Onondaga County Department of
Water Environment Protection
Syracuse Metropolitan WWTP Digester
Cleaning and Miscellaneous Repairs Project
Technical Report

TECHNICAL REPORT
SYRACUSE METROPOLITAN WWTP DIGESTER CLEANING
AND MISCELLANEOUS REPAIRS PROJECT

**INTERIM INSPECTION REPORT (Revised January 31, 2013)
DIGESTER NO. 1
METRO SYRACUSE WWTP DIGESTER CLEANING AND MISCELLANEOUS REPAIRS
ONONDAGA COUNTY, NEW YORK**

INTERIM INSPECTION REPORT
(April 12, 2012, Revised January 31, 2013)
DIGESTER NO. 2
METRO SYRACUSE WWTP DIGESTER CLEANING AND MISCELLANEOUS REPAIRS
ONONDAGA COUNTY, NEW YORK

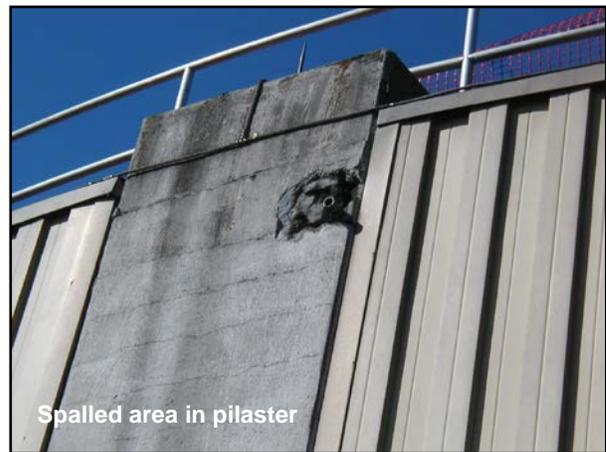
The insulated roof appeared to be in fair condition, with different areas of the hard shell broken through. Some of these broken shell areas appear to have been previously repaired. It is estimated that less than 5 percent of the roof area has this type of damage. We recommend patching the broken shell

areas. This work would require a modification. During Phase 2 of the digester repairs, we recommend all of the insulation on the roof be replaced.

1. Patch spalled area in concrete floor. This work will be covered under Unit Price Payment Item 5.
2. Patch insulation on roof. This work would require a modification.

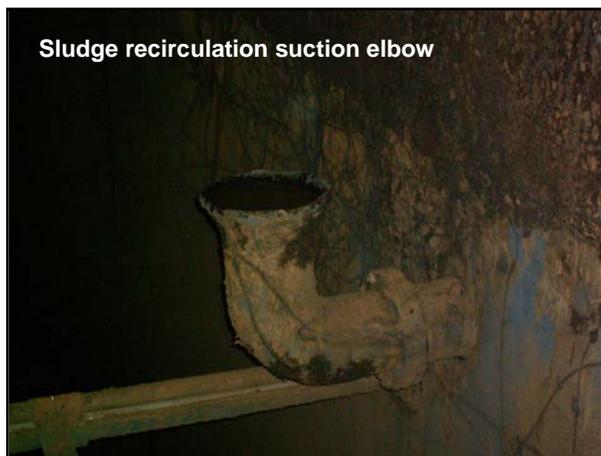
The high sludge feed pipe has significant internal buildup of scale and the working diameter of the pipe has been greatly reduced. We recommend replacing the high sludge feed pipe back to the last isolation valve in the Digester Control House. The new pipe will be 8-inch flanged ductile iron pipe with a plain end discharge. The approximate length of pipe to be replaced is 75 feet. We recommend the new sludge feed pipe match the existing layout and the existing supports be reused. This work would fall under Unit Price Payment Item 8.

5. Replace high sludge feed pipe. This work will be covered under Unit Price Payment Item 8.
6. Flush and drain the sludge recirculation line. This work is part of the lump sum.

Gas feed piping and supports

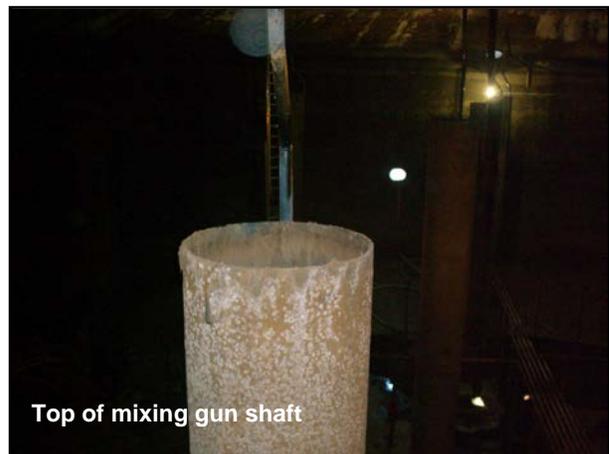
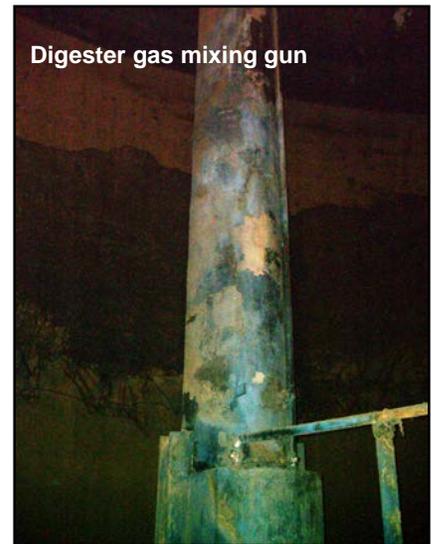
The estimated quantity to be replaced is 65 pipe supports, each approximately 7 to 10 feet tall. A modification will be required to complete this work. We recommend obtaining a proposal from the contractor to replace all of the pipe supports. If the price exceeds the budget of the project, an alternative approach is to replace only the most severely corroded pipe supports (those that have corroded away at the bottom), and replace the remaining as part of Phase 2.

9. Replace gas feed pipe supports. This work would require a modification.
10. Clean the residue off of the inlet and flush the roof drains. This work would require a modification.

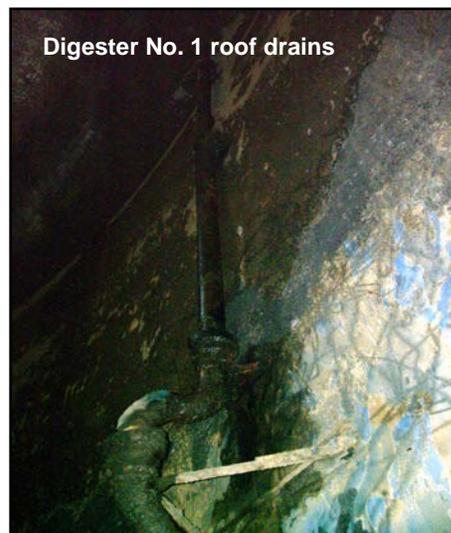
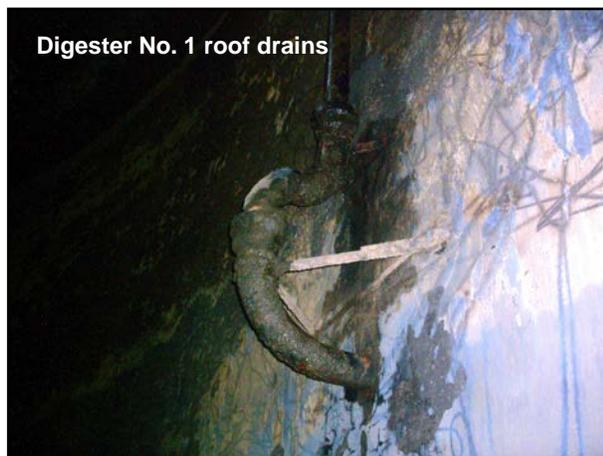
The roof drains are believed to be cast iron and original with the digester. They appeared to be leaking. We also observed that the inlets of the roof drains on the exterior of the digester cover were covered with residue. The drain pipes could be plugged and this could be the reason for the leaking. We recommend the contractor clear the drains of this residue. Once the residue is cleared and the drains can be seen, we recommend the drains be flushed with water and verify they are properly draining to the manhole. A modification will be required to complete this work.

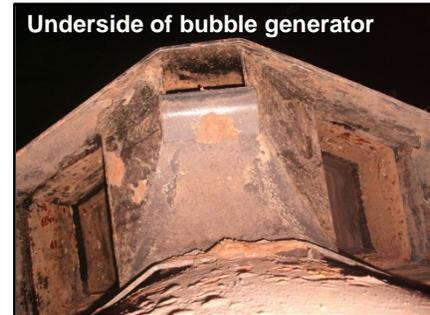
This mixing guns appear to be in fair condition; however, much of the coating has worn off of the mixing gun tube. The cost of recoating the mixing guns for Digester No. 2 would be approximately \$120,000.

Due to the time and cost required to recoat the mixing guns, it is recommended that this work be completed during Phase 2. Coating has also worn off the carbon steel bubble generators, resulting in some corrosion around the throttle plate openings on some of the mixers. In Phase 2, it is recommended to either recoat the bubble generators or replace with stainless steel. In addition, mats of hair were seen on the inside of the mixing guns and it did not appear they had been cleaned. The inside should be cleaned/power washed as part of the contractual work of this project.

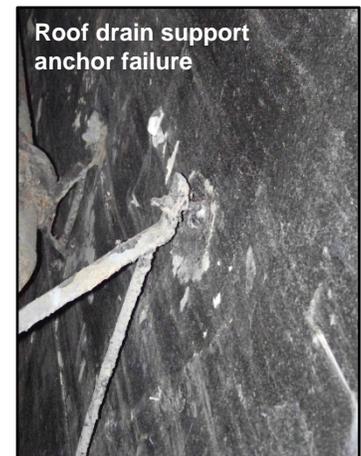
Some of the roof drain support anchors and the coating system on the supports have also failed. The roof drains/supports appear to be in poor condition; however, replacing them

while the digester is out of service is not a necessity. Because of this and the budget constraints of the project, we recommend replacing all three roof drains and supports with new cast iron pipe and stainless steel supports in Phase 2.

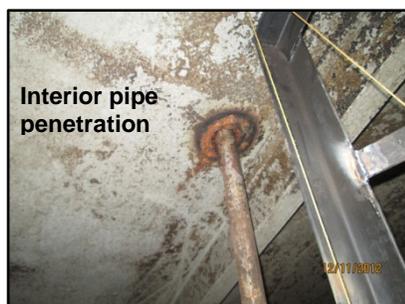
The 2-inch flushing line penetrations were observed. The County staff and the contractor aided in the inspection of these penetrations. On the exterior of the roof, some corrosion of the steel sleeve was observed, but most of the corrosion was from the mixer I.D. tag chain. The County staff and the contractor removed the foam insulation filling the space between the sleeve and pipe at one of the penetrations in order to observe the link seal. When removing the insulation, it was found that there was approximately a 1- to 2-inch water column sitting on top of the link seal, indicating the link seal was not leaking. The County staff removed the water using compressed air. The top of the link seal was observed and appeared to be in fair condition. On the interior, it was difficult to observe the link seal. There was also corrosion around the pipe penetration area.

Since the link seals do not appear to be leaking, it is not recommended to replace them at this time. However, it is recommended that the link seals be replaced during Phase 2, along with sandblasting and recoating the sleeves, at the same time the roof is rehabilitated. As an immediate repair, it is recommended that the pipe penetrations on the exterior be sealed to prevent further water damage. The deteriorated foam insulation should be removed and new spray foam insulation added to fill the void space. One solution to preventing water from entering the gap between the pipe and sleeve is to install a Fernco-type coupling over the area.

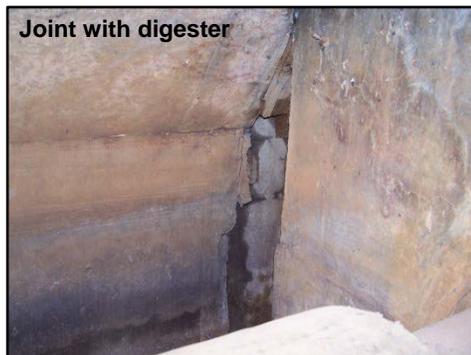
Mixer #10 showed corrosion around the bottom perimeter of the draft tube. This corrosion should be surface prepared for recoating and recoated while the digester is out of service.

Replacing throttle plates is covered under Payment Item 13, Steel Repair. Repairing the corroded areas is covered under Payment Item 11, Miscellaneous Painting/Coating.

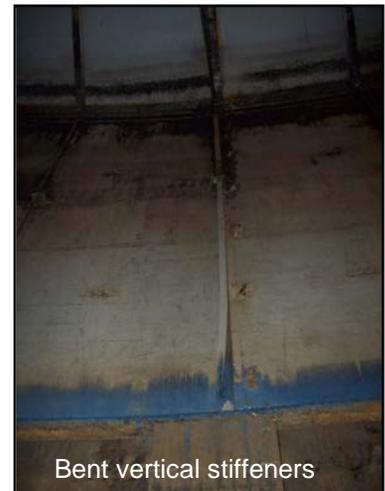
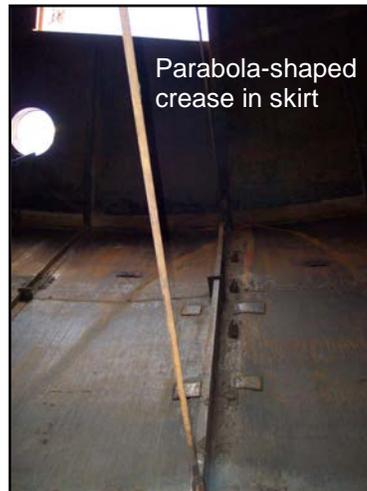
Due to the time constraints for surface preparation and paint application, we do not recommend recoating the entire cover at this time. We anticipate it would take a minimum of two months to perform sandblasting and coating of the entire cover. This includes disconnection and reconnection of all the tie rods, resetting scaffolding, and lead abatement measures. This would delay the return of the digester to service and its benefits in providing supplemental heating. Secondly, since we did not measure any loss of thickness between structural members, we believe the corrosion is limited to the surface. However, we recommend that this be verified by ultrasonic thickness measurements. This testing could be completed from the exterior of the digester, at any time. According to the manufacturer, the panels are typically 1/4-inch thick, with 1/8-inch thickness for structural integrity and 1/8-inch thickness for corrosion allowance.

In the future, if the cover is to be rehabilitated, we recommend removing the entire cover from the digester to aid in a full rehabilitation of the cover and tank, including: (1) sandblasting and recoating the cover; (2) sandblasting and recoating the center column; and (3) sandblasting and recoating concrete walls. However, before rehabilitation is done, ultrasonic thickness testing should be completed again to determine if there is any loss of thickness. Also, the cost of cover replacement should be compared with the cost of rehabilitation. This evaluation will be done as part of the Technical Report in Task 6.

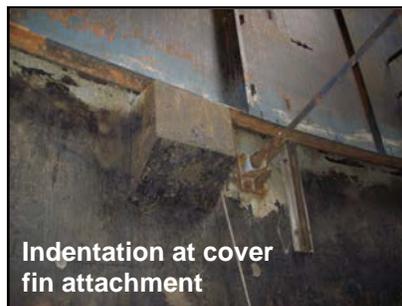
These diagonal tie rods are necessary for the structural integrity and balance of the cover over its range of travel. Therefore, it is recommended to replace as necessary and reinstall the tie rods before the digester is placed back in operation.

- The six horizontal tie rods (Type C) appear to be in good condition and were intact with the exception that some of them were slacked. These tie rods are also composed of sections joined with threaded turnbuckles. We recommend all of these rods be retensioned.
